Number P.1
Section Electrical and Instruments
Sheet 1 (of 1)
Date January, 1960

INSTRUMENTS, OVERDRIVE AND AUTOMATIC TRANSMISSION INDICATOR LIGHTS

JAGUAR SERVICE BULLETIN

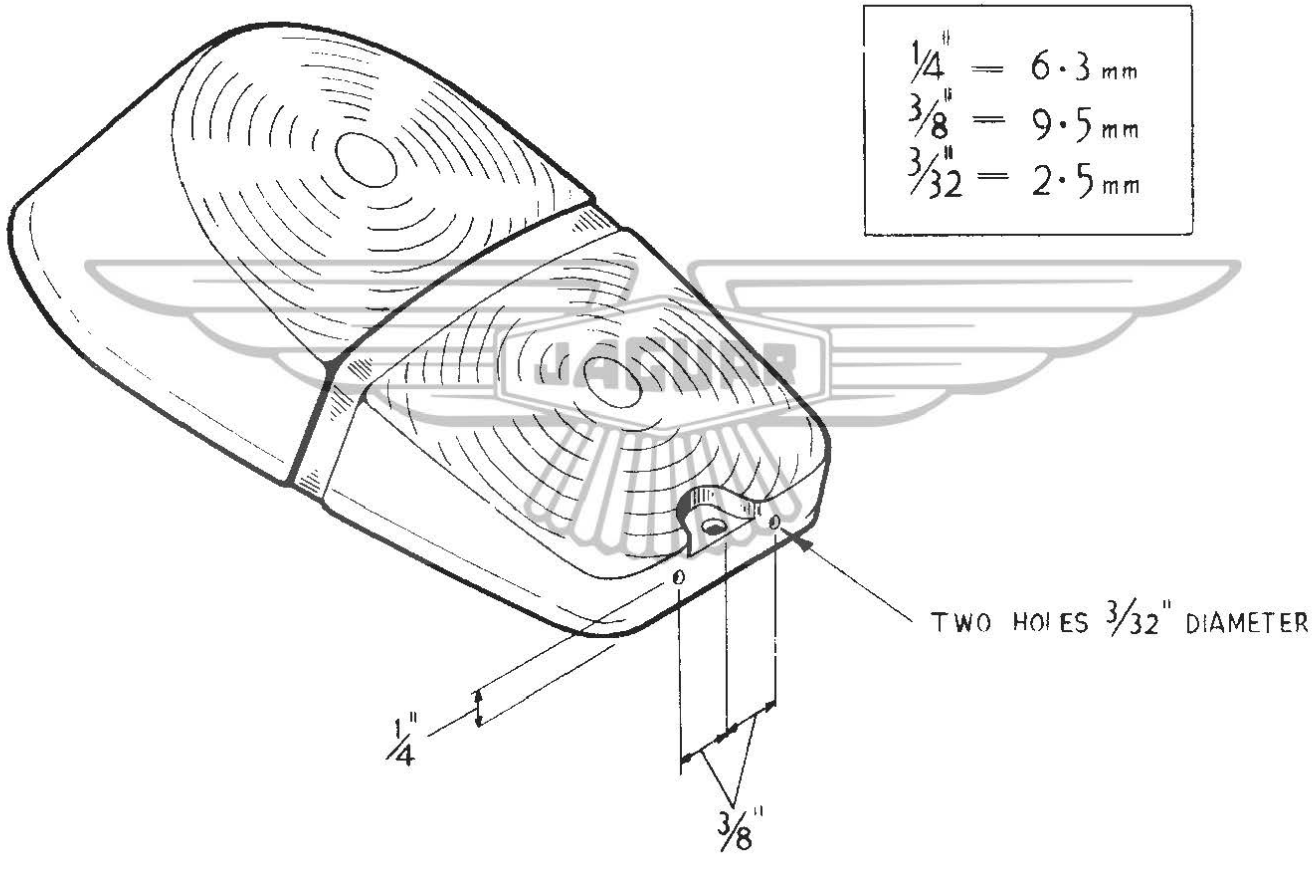
A certain number of 1960 cars with the new type rear lamps (with separate flasher and tail light bulbs) were sent out of the factory without the drain holes in the bottom of the lamp lens.

Cars in stock or cars coming in for servicing should be checked for having two holes drilled in the bottom of the rear lamp lens. If not so drilled, two holes should be made in the bottom of the lens as shown in the sketch overleaf.

FIG 2

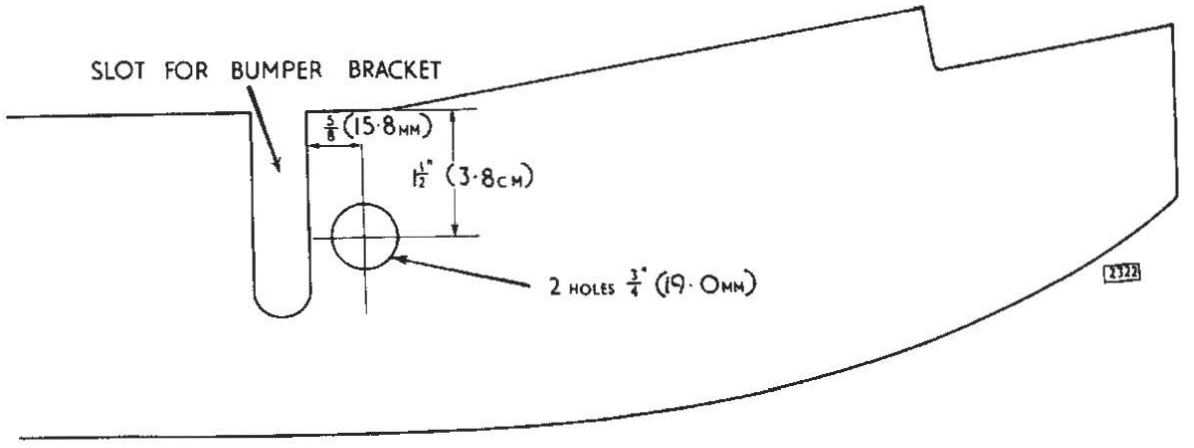
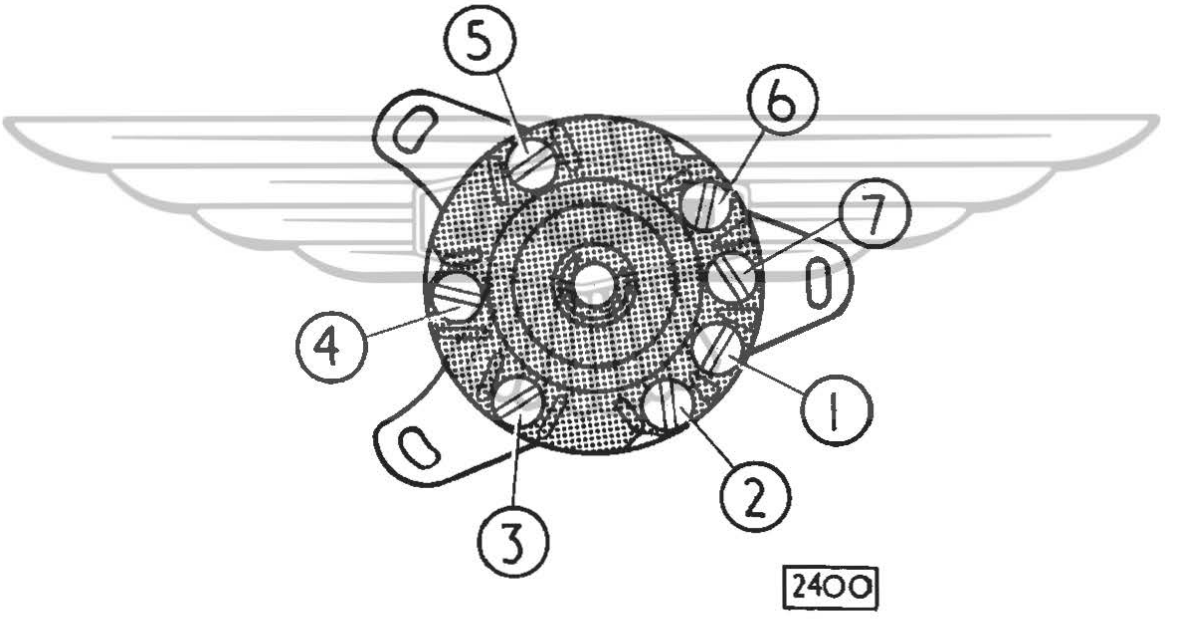
Remove the printed circuit resistance from the original switch (terminals 2 and 11) and refit to the new switch (terminal 2 - 4)

Replace the cables as shown in Fig.2. and connect the red/yellow cables, incorporated in the harness, to the foglamp terminal.

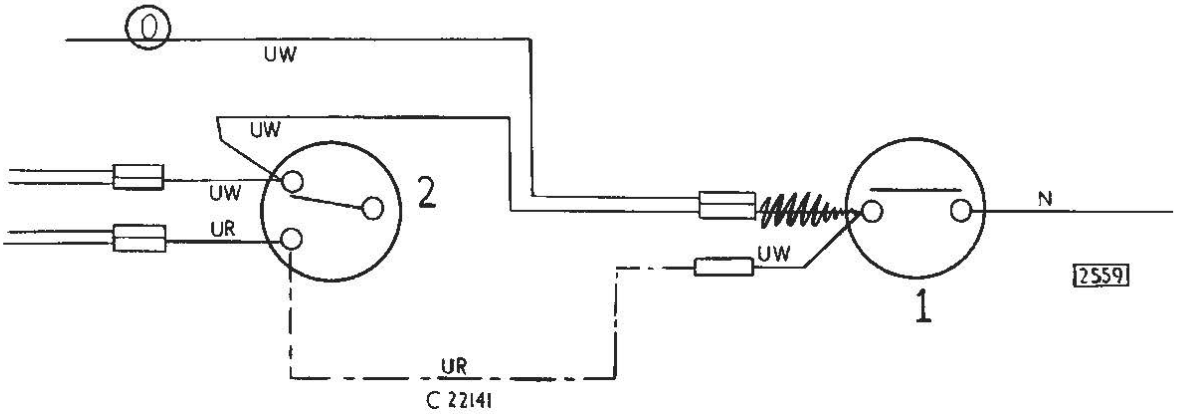
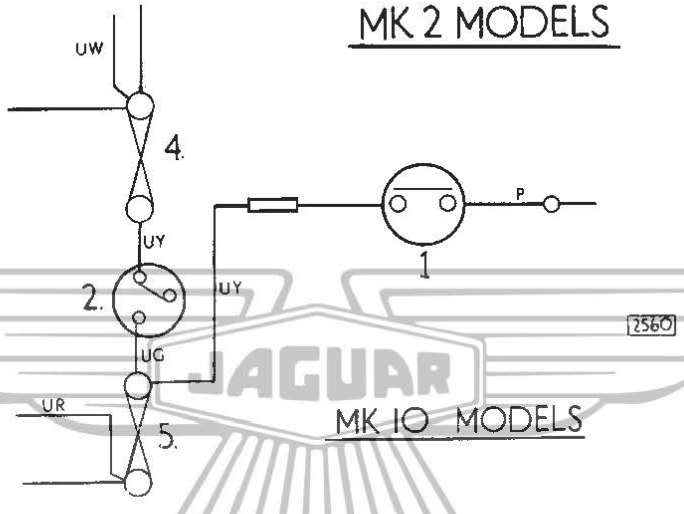
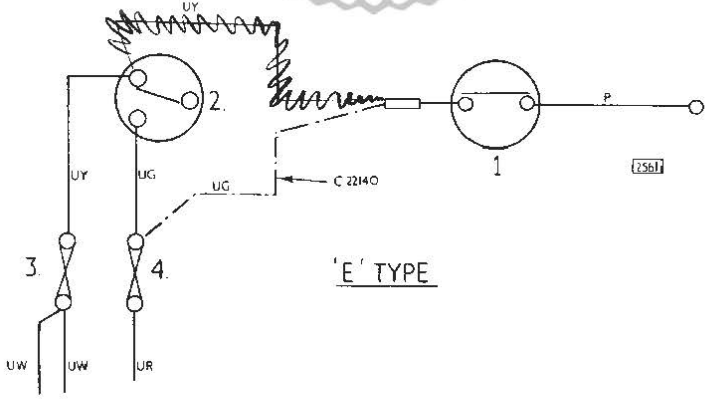
The amended wiring circuits are shown overleaf.

DISTRIBUTOR MODEL 22 D6

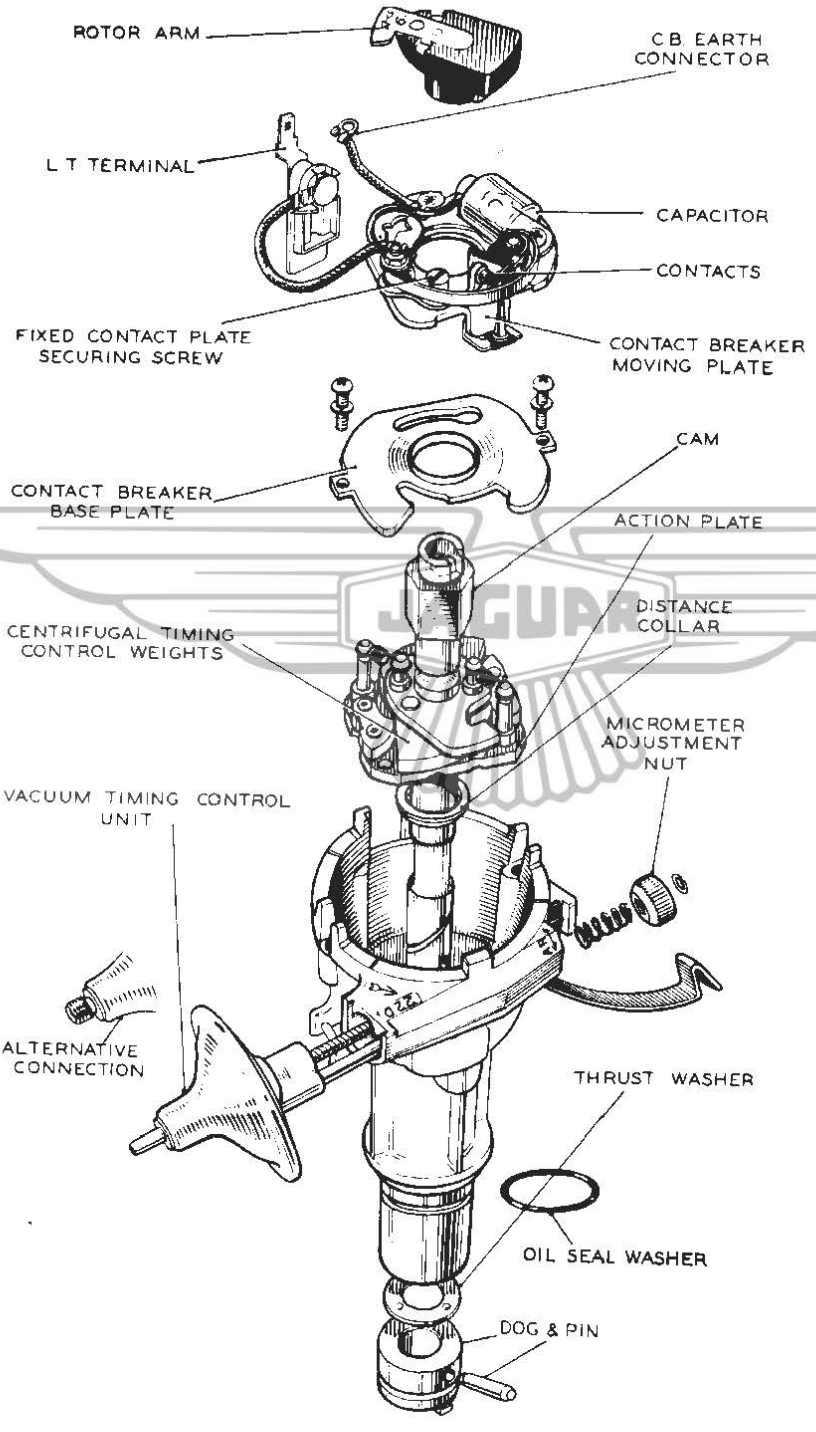
INTRODUCTION OF MODIFIED DISTRIBUTOR.

DISTRIBUTOR MODEL 22 D6

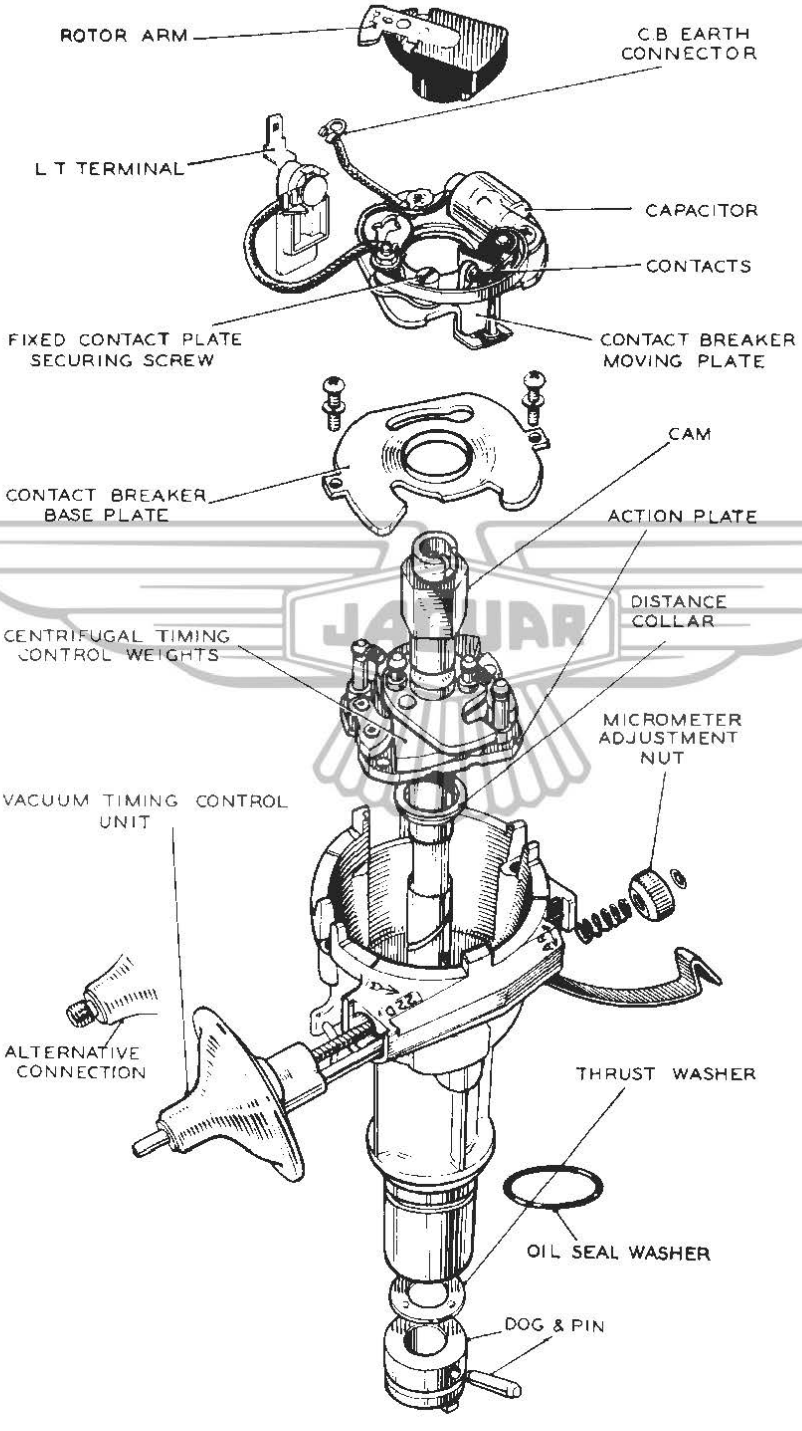
INTRODUCTION OF MODIFIED DISTRIBUTOR.

The correct gap is .014" - .016" (.36 mm - .41 mm).

MODEL C40L GENERATOR

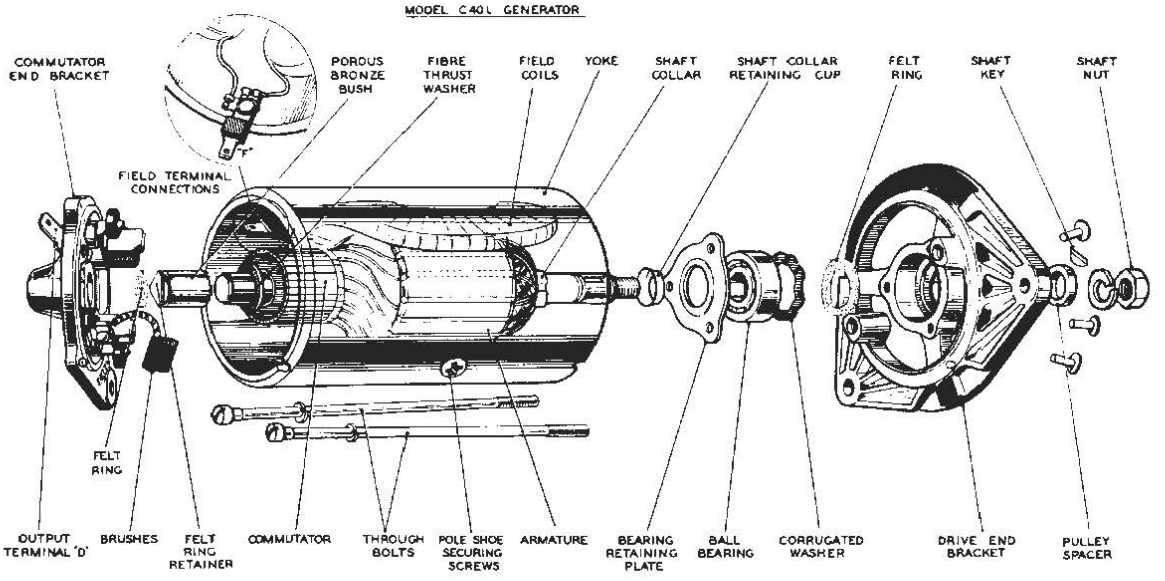
All current production Mark 2 cars are now equipped with a different type dynamo and control box. The illustrations show the C.40L dynamo fitted to 2.4 litre cars and the C.42 dynamo fitted to 3.4 litre and 3.8 litre cars.

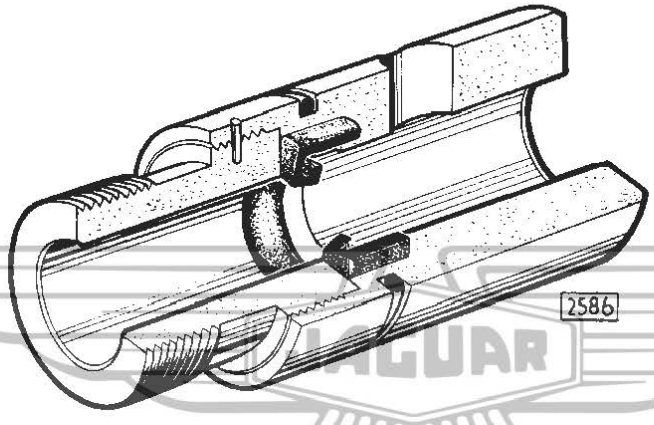
Remove the rubber seal from the recess in the bearing. Fit a new seal (Part No. C.8773) so that the open end of the seal through which the spring is visible, is facing the bottom of the recess of the bronze bearing (See illustration overleaf).

AUTOMATIC TRANSMISSION CARS

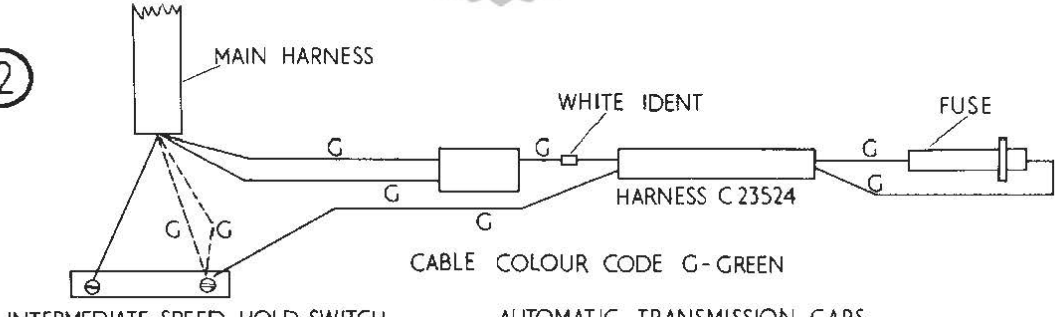
DOTTED LINES SHOW MAIN HARNESS CABLE TO BE MODIFIED

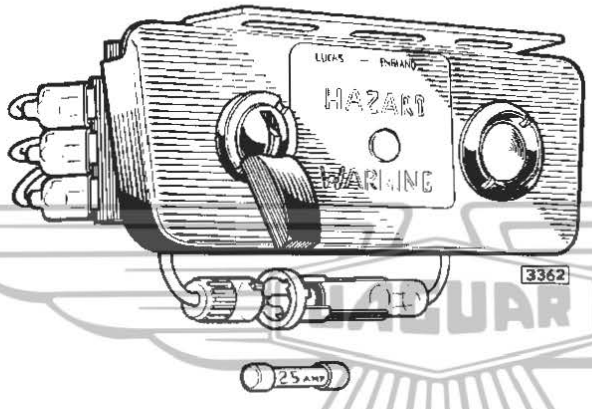
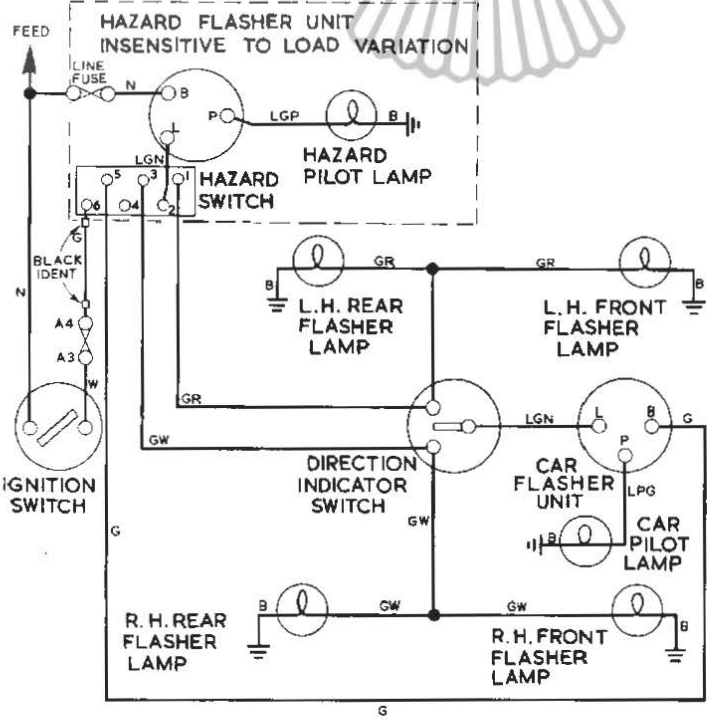
See illustration for circuit diagram.

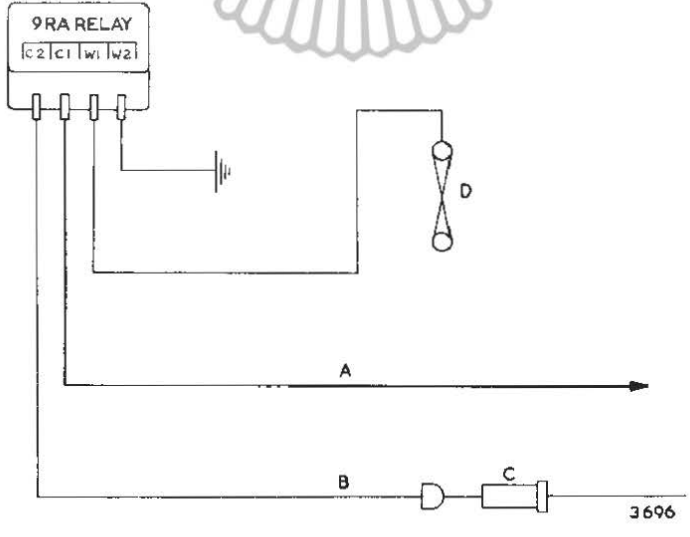
To prevent this fault recurring, a Lucas 9 RA Relay (Part No. C.19085) has been introduced into the Air Conditioning Electrical circuit on current production cars, the revised circuit being as illustrated.

If complaints are received of ignition switch failure, it is recommended that the relay is fitted in a convenient position and the circuit modified. The main output terminal (A) should have a 35 amp terminal fitted to connect to the alternator.
